REMARKS

Attorney Docket No. L8612.04117

FIG. 1
PRIOR ART

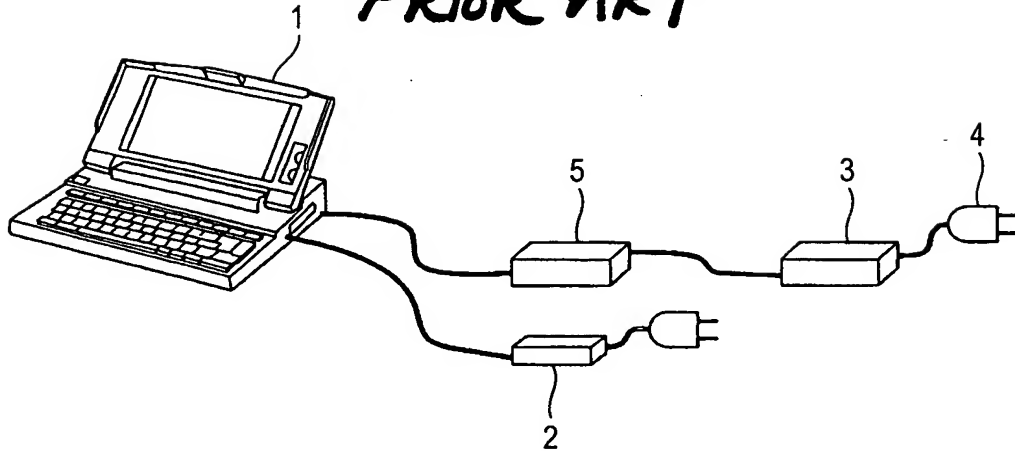
As required in the Quayle Action, proposed changes to Fig. 1 are submitted herewith, with a Letter to the Official Draftsman, labeling Fig. 1 as "Prior Art." A sheet showing the changes in red ink and a replacement sheet are attached.

A proposed change to Fig. 1 is submitted herewith with a Letter to the Official Draftsman.
